ADDENDUM #1

Reference: Parleys Maintenance Station #234 Improvements
Utah Department of Transportation - Utah
DFCM Project No. 08211900

DFCM Project No.: 08211900
Archiplex Group Project No.: 0728.02

ADDENDUM NO. 1 to the Contract Documents for the Construction of UDOT Maintenance Station #2434, Parleys Canyon, Utah.

C100

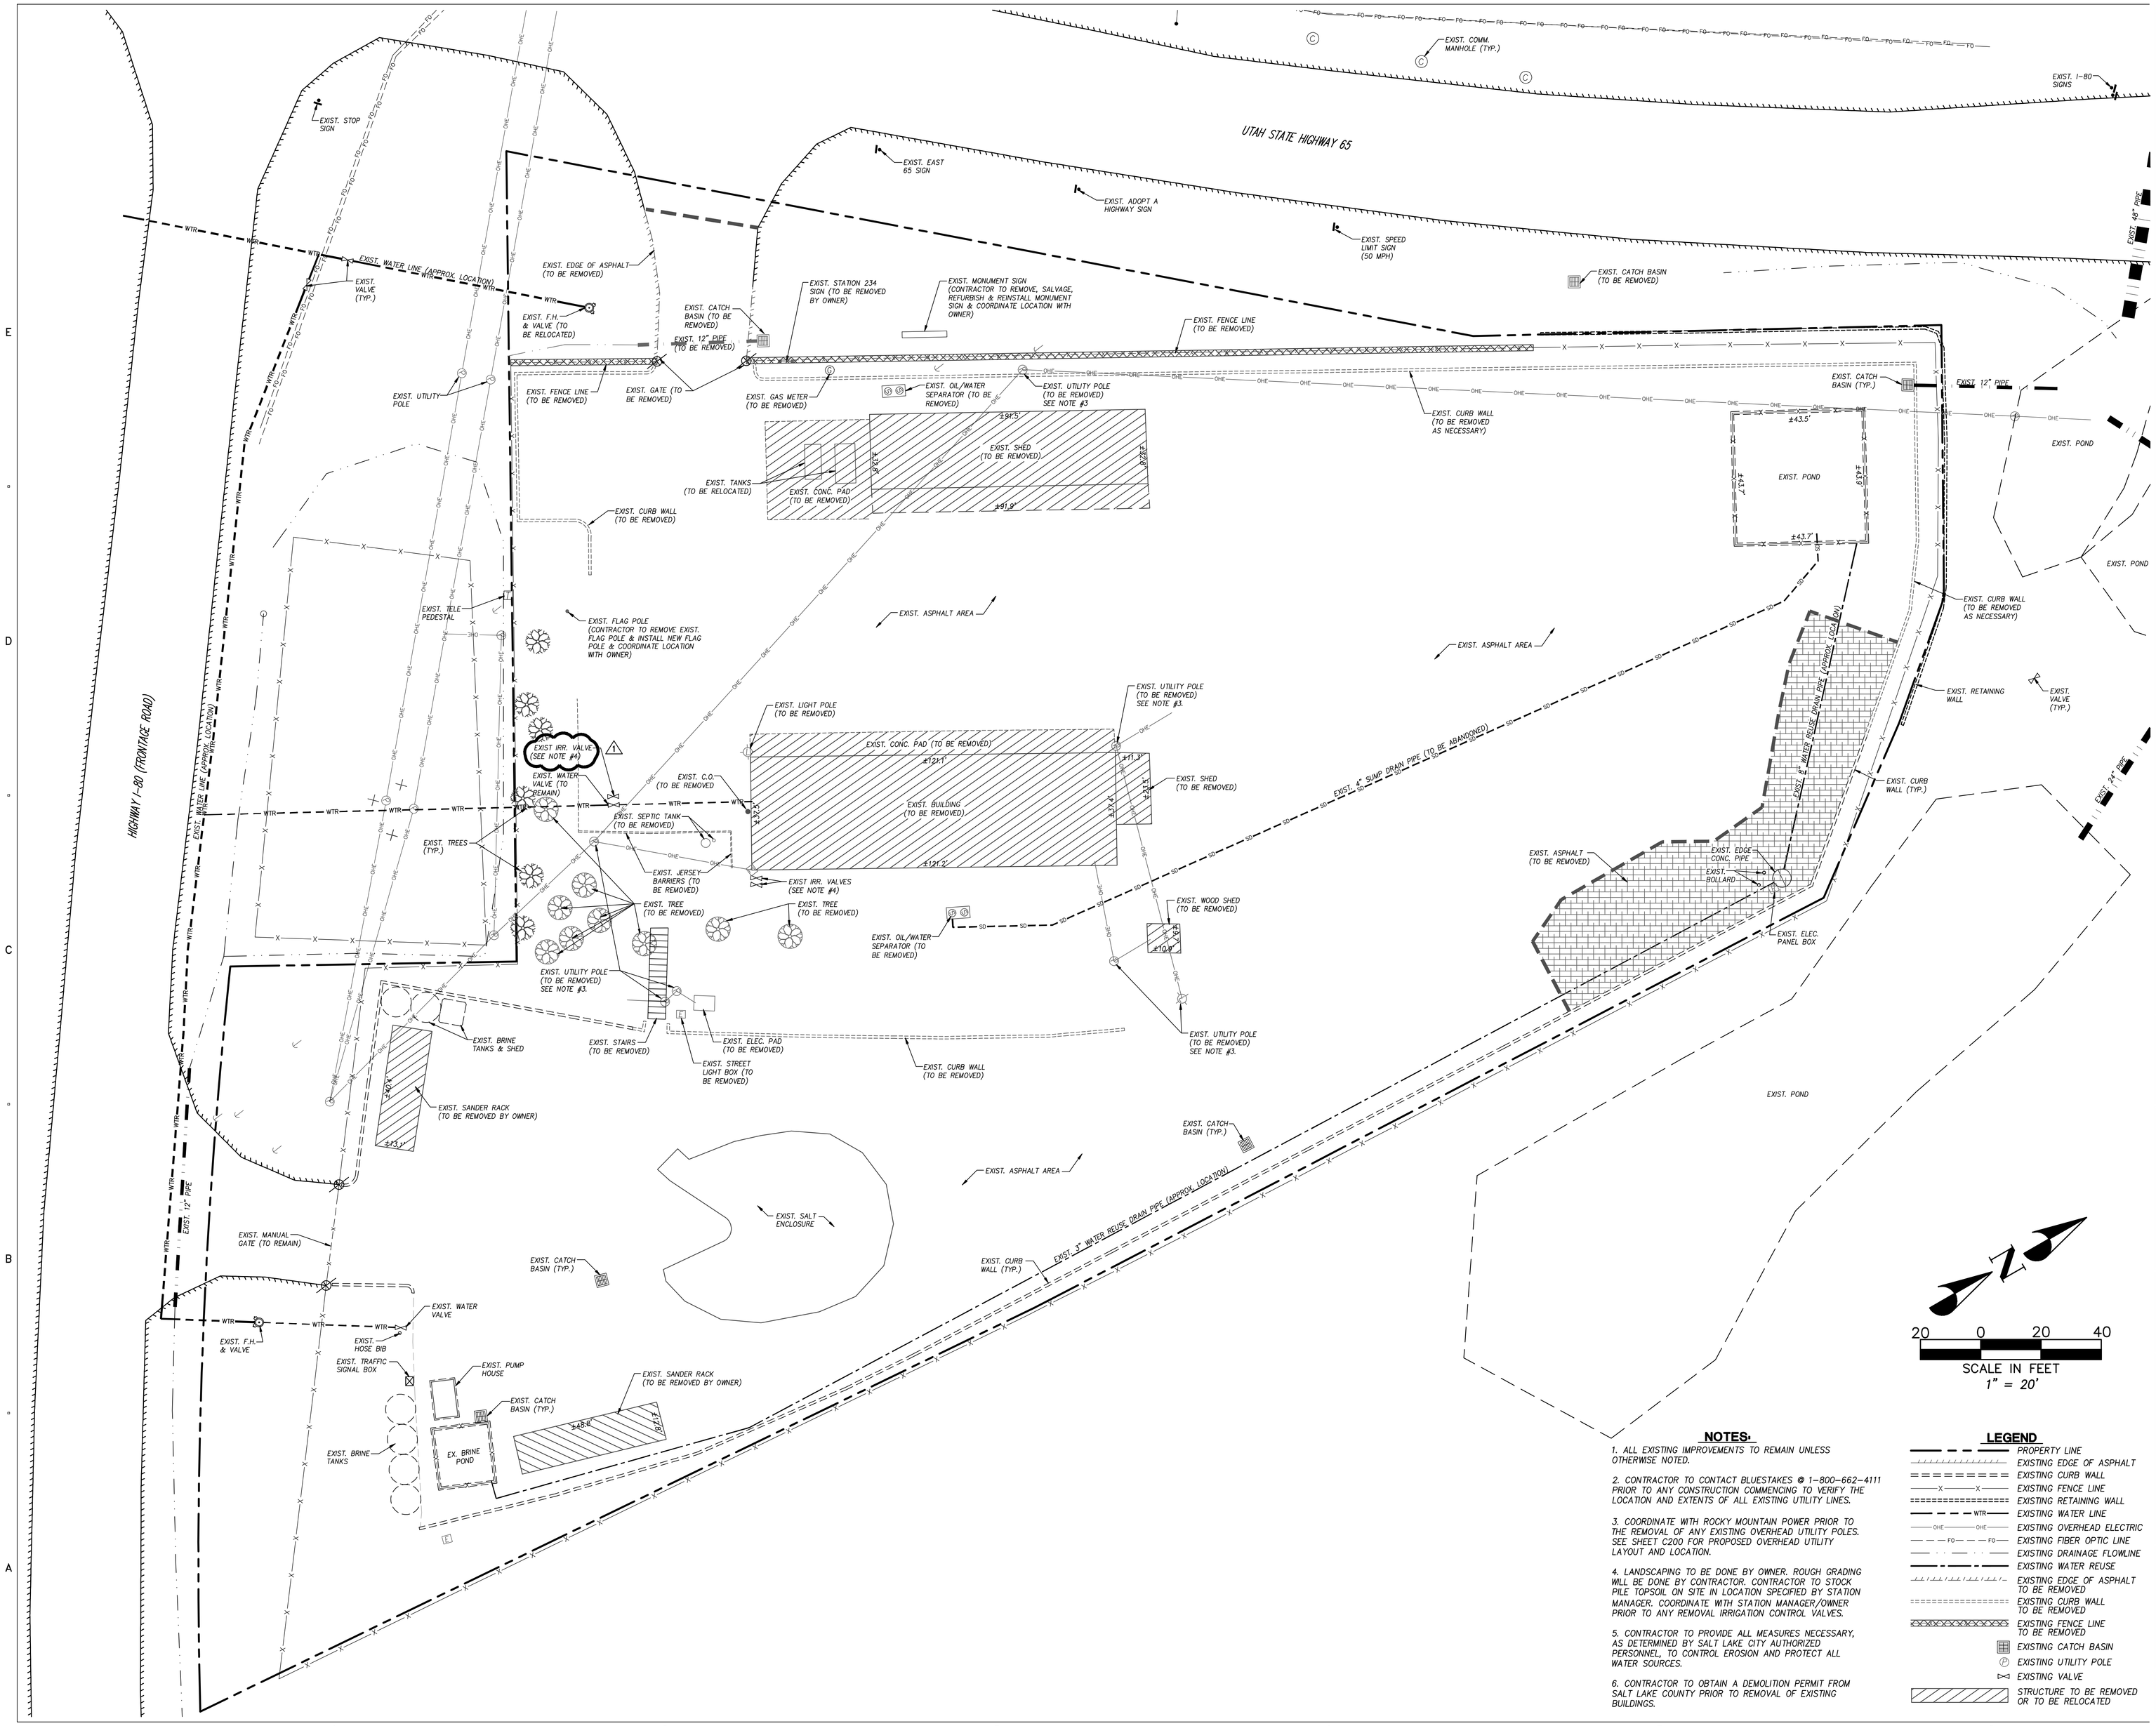
Sheet C100:

a. Removed existing irrigation valve.
b. Modified Note #6.

C200

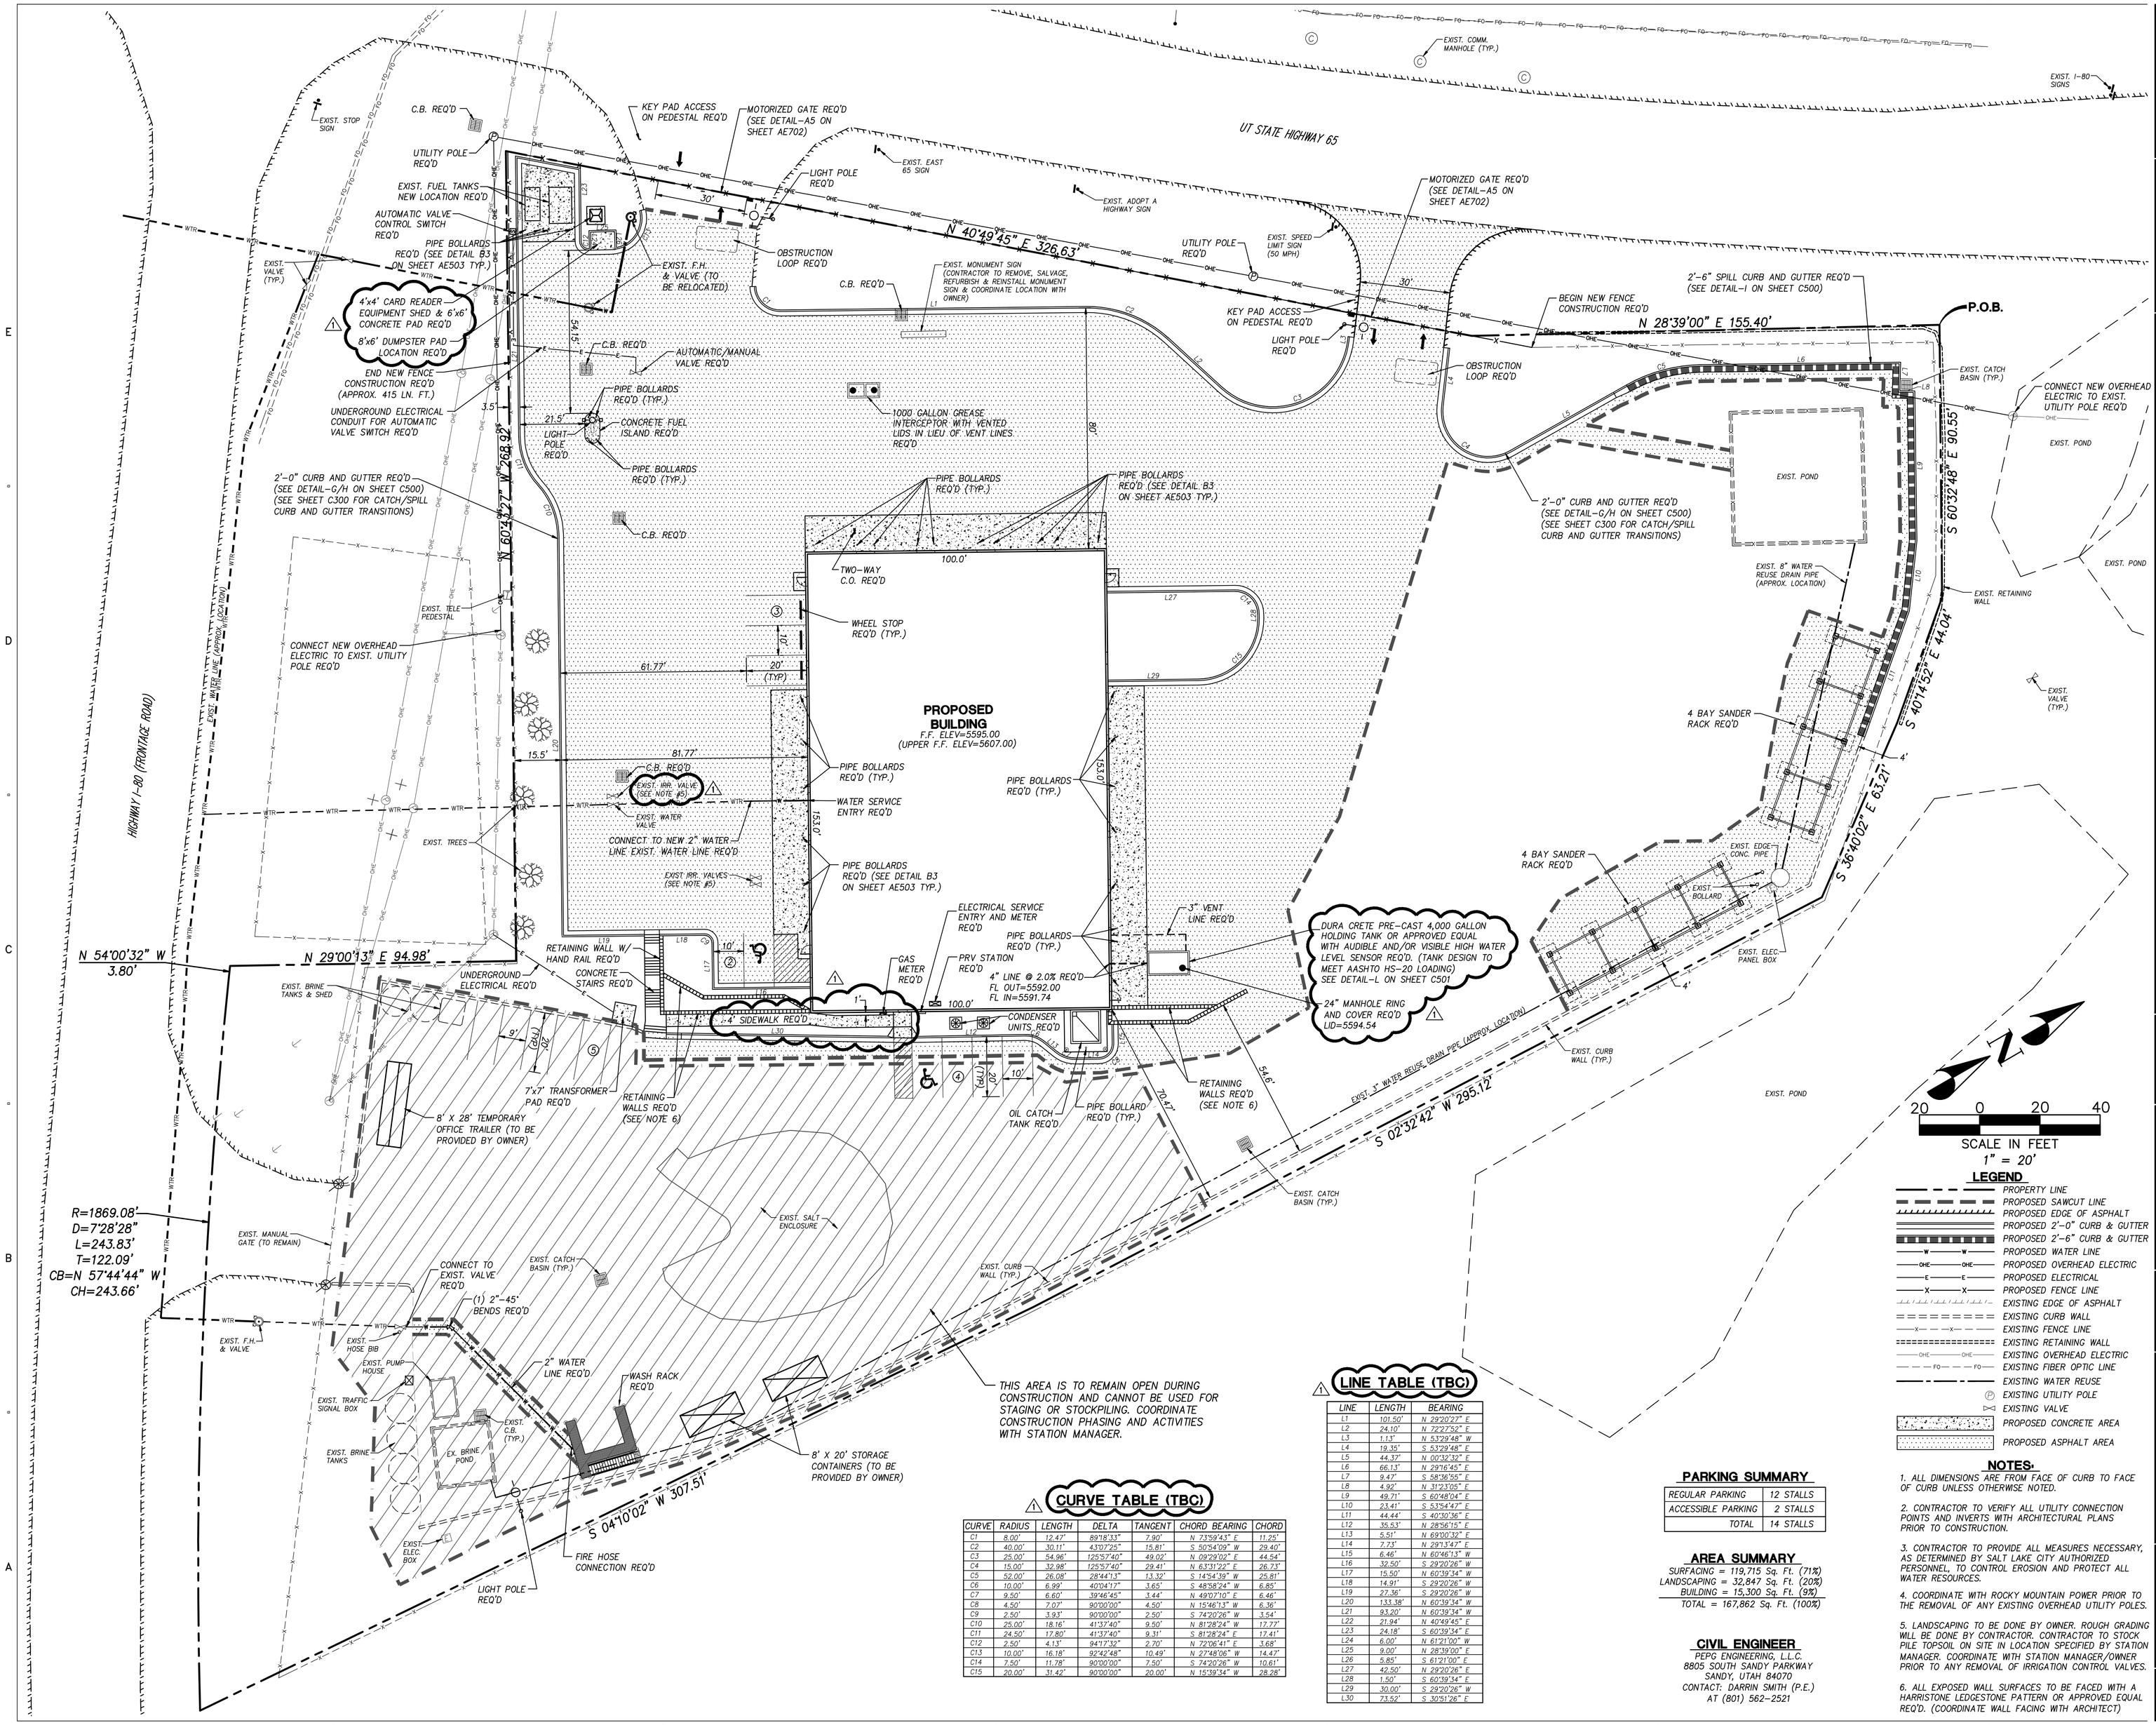
Sheet C200:

a. Added Dumpster pad size.
b. Added Card reader pad size.
c. Removed existing irrigation valve.
d. Removed light pole from Sander Rack location.
e. Added TBC curve and line tables.
f. Revised Sidewalk @ gas meter.
g. Revised Holding tank & manhole note.
h. Modified Note #6

C301

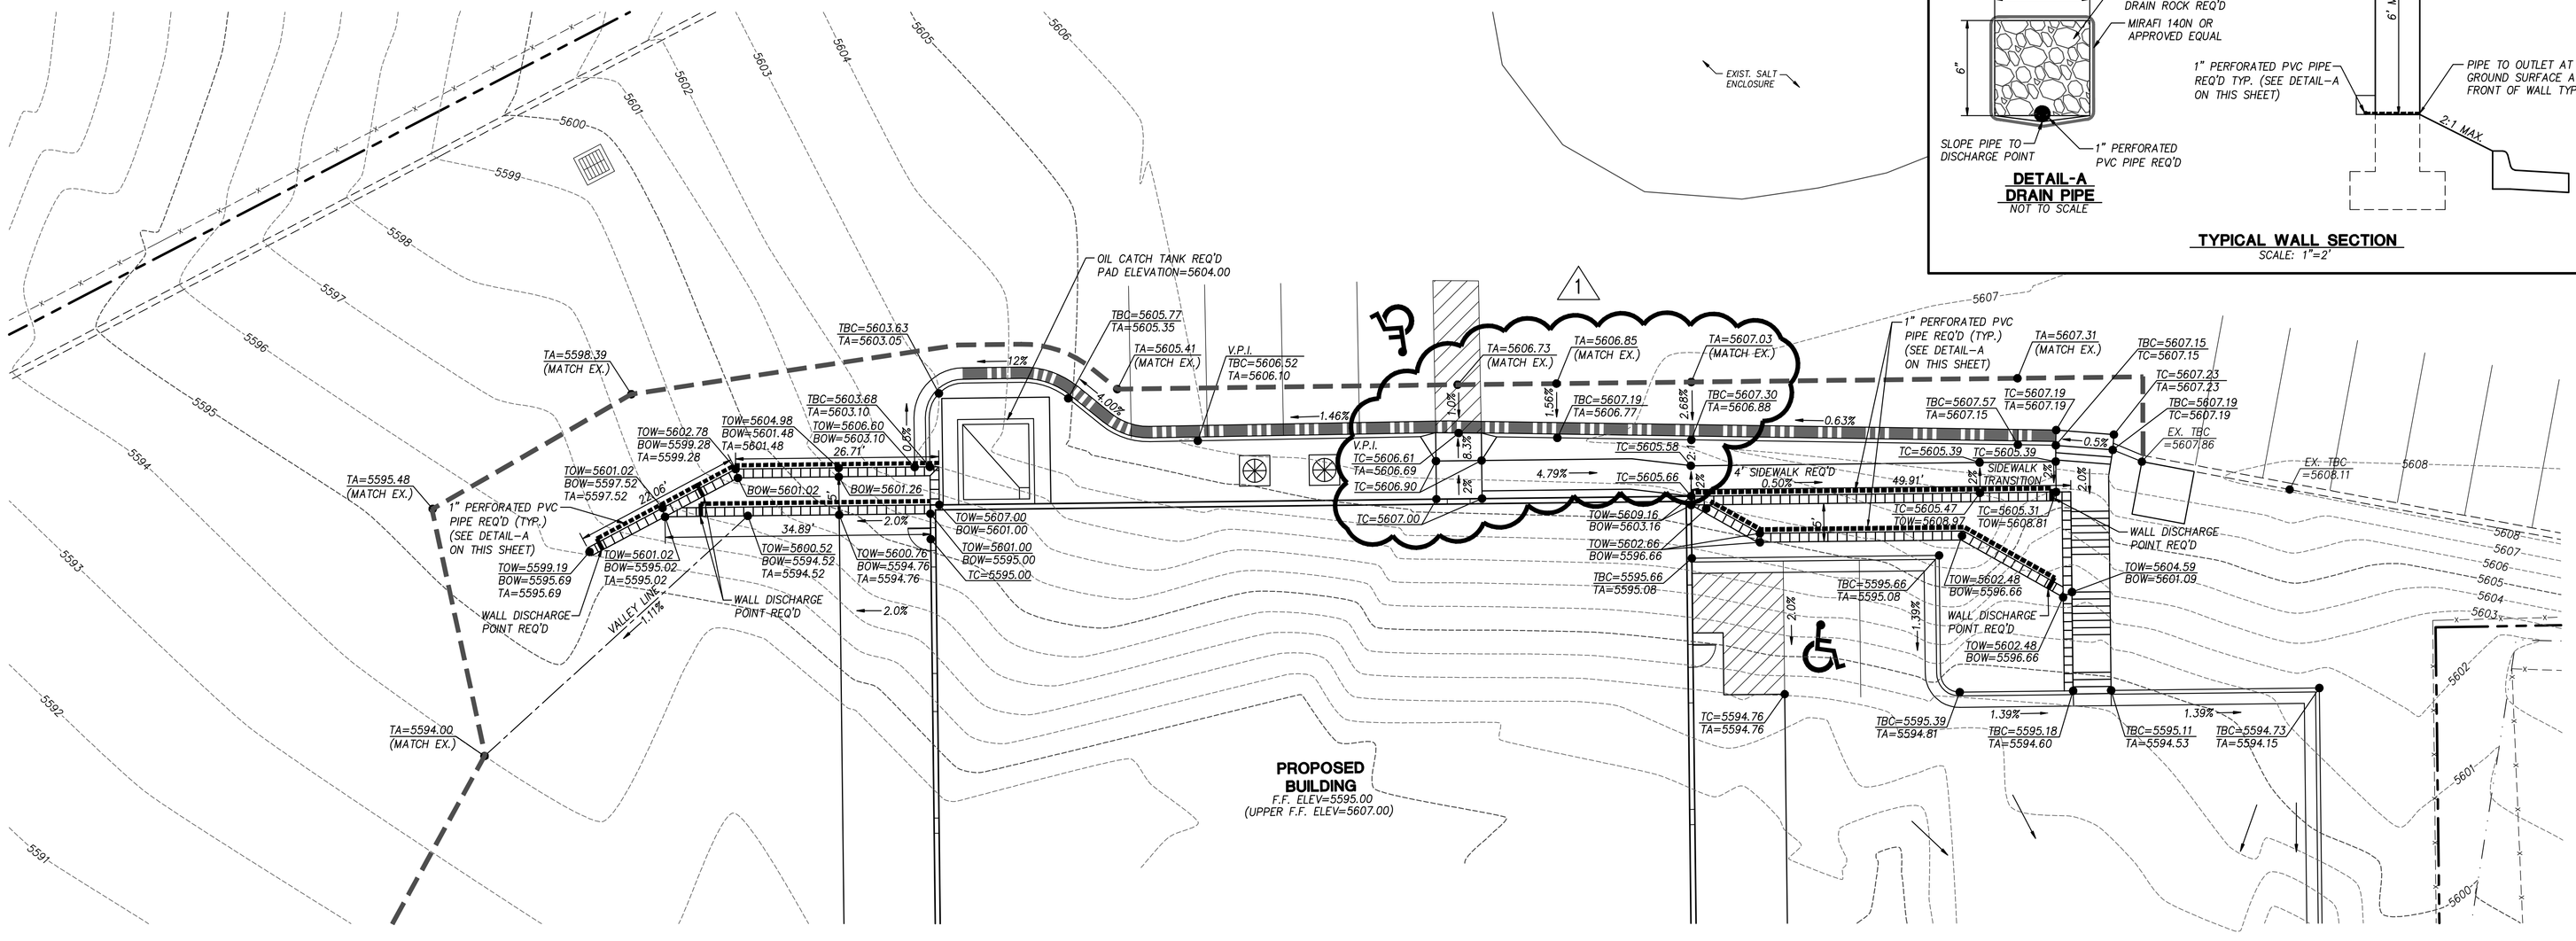
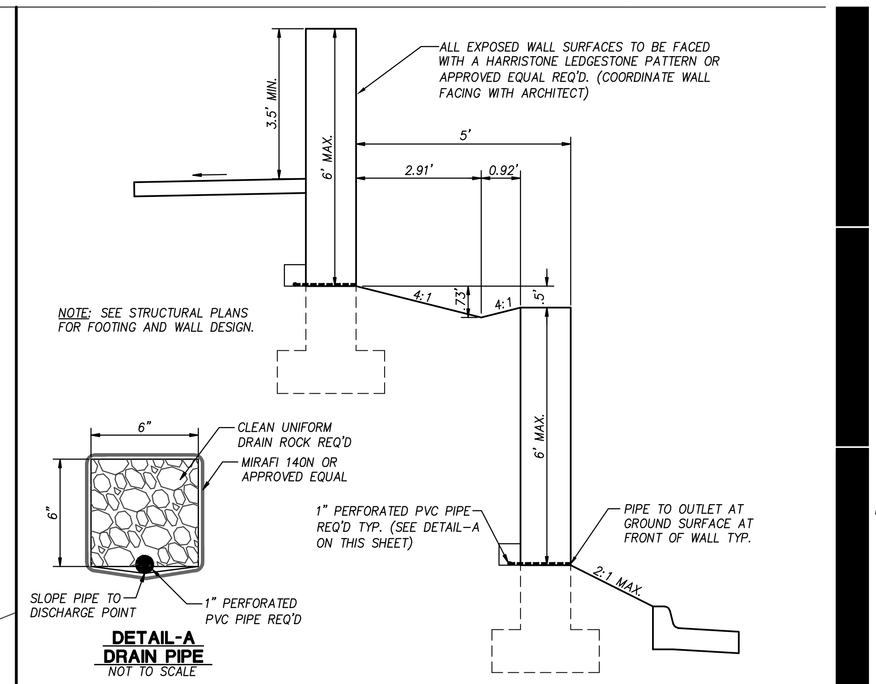
Sheet C301:

a. Modified typical wall section.

b. Modified East Sidewalk layout.
